Mask Set Errata 3

MC68HC912DG128 Microcontroller Unit

This errata provides information applicable to the following MC68HC912DG128 MCU mask set devices:

- 5H55W.A

Figure 2. Representation of unreliable start-up mode with slow crystal

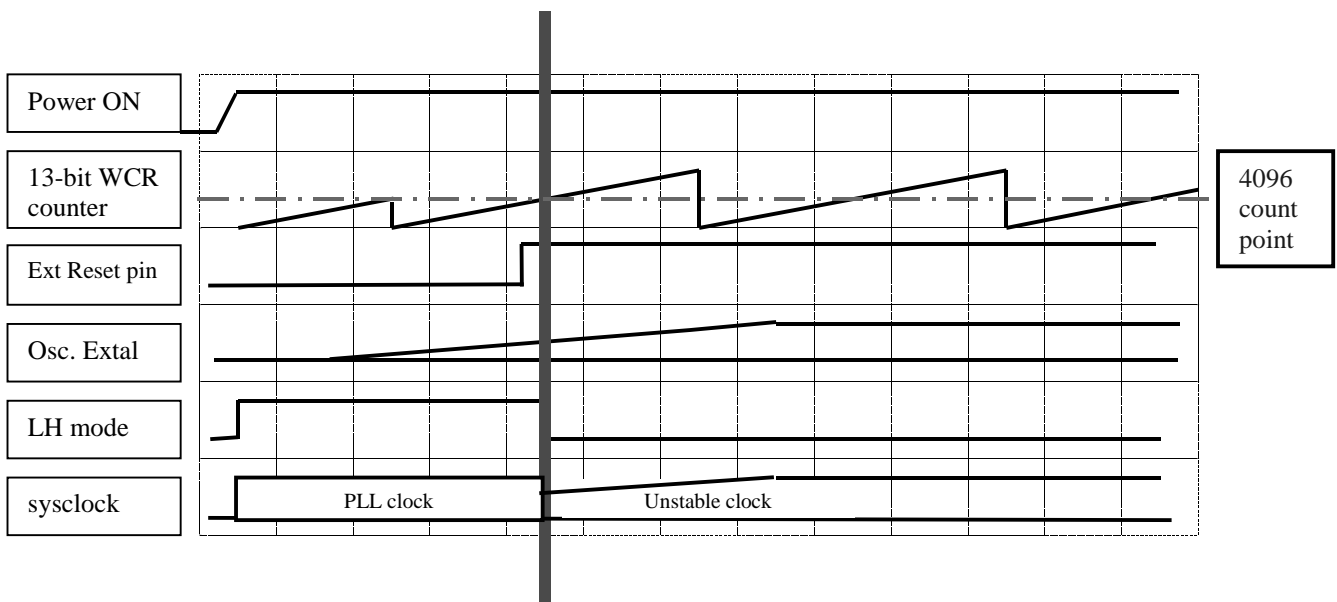
The HC12 mode of operation known as Limp-Home Mode (LHM) is enabled when the VDDPLL pin is at VDD and is entered if for any reason the external crystal ceases to oscillate. During this mode the CPU will be clocked from the free-running VCO clock of the PLL (at a nominal frequency of 1MHz). If LHM is enabled during the start-up phase (i.e. VDDPLL=5V, NOLHM bit=0) and the external RESET line is not held active until after the crystal frequency is stable then the device starts up in LHM since no crystal oscillations will be detected. This situation can arise with short reset periods and/or crystals that exhibit slow start-up characteristics.

For the first 4096 cycles i.e. during the internal reset period, Limp Home mode will be de-asserted if oscillator activity is detected by the clock monitor circuit -due to the asserted Reset signal there can be no CPU activity during the Reset phase. Following release of the external or internal POR RESET in LHM (which ever is

later) the crystal oscillator is sampled by the clock monitor circuit after another 4096 VCO clock cycles and at intervals of 8192 clock cycles thereafter until the crystal is deemed to be operating. If the crystal oscillator is showing activity at the time it is checked then it will be deemed to be good, even though it may not have fully stabilized, and LHM will be de-asserted. This can cause the device to switch from LH mode to normal mode with the CPU clocked from an unstable signal from the crystal oscillator (see fig. 2) resulting in unpredictable function of the CPU.

Figure 3. Representation of preferred means of overcoming issue with Figure 2

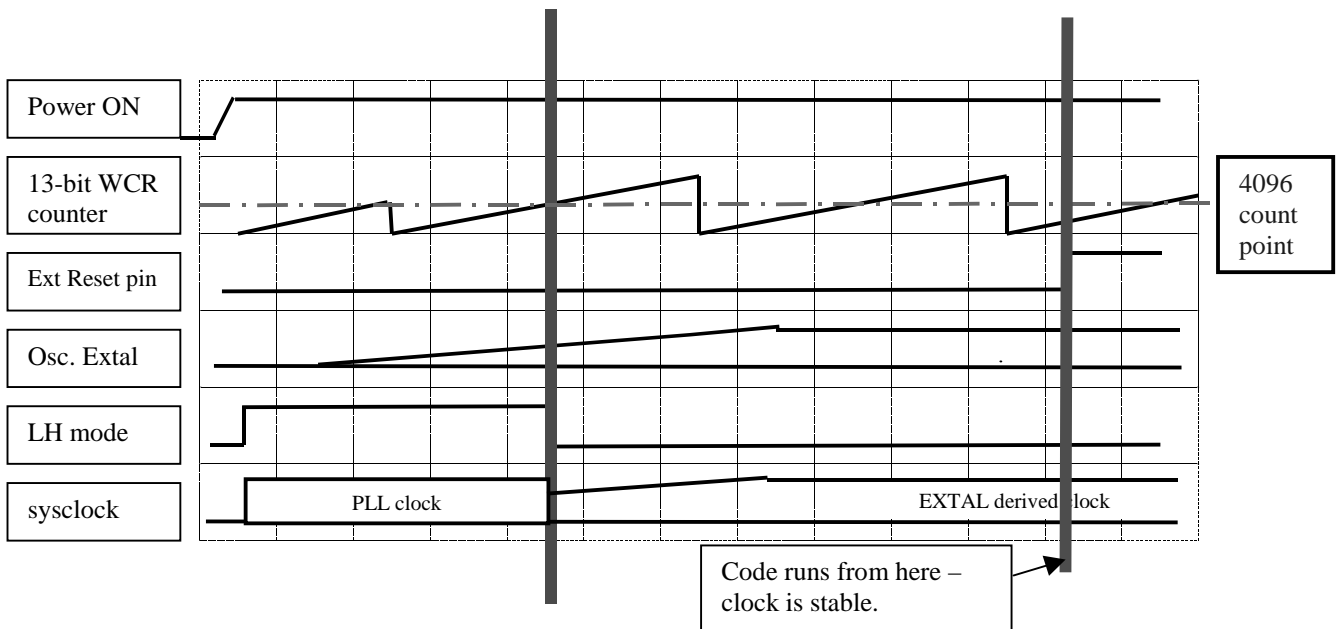
The Reset condition can be overcome by allowing the crystal oscillator circuit to stabilize before releasing the external RESET line (see fig. 3). Operation is similar to that shown in fig 2.

Lastly, an alternative and simpler approach is to just hold reset low for a substantial time (> 100 milliseconds) after Vdd has reached the operating voltage range.
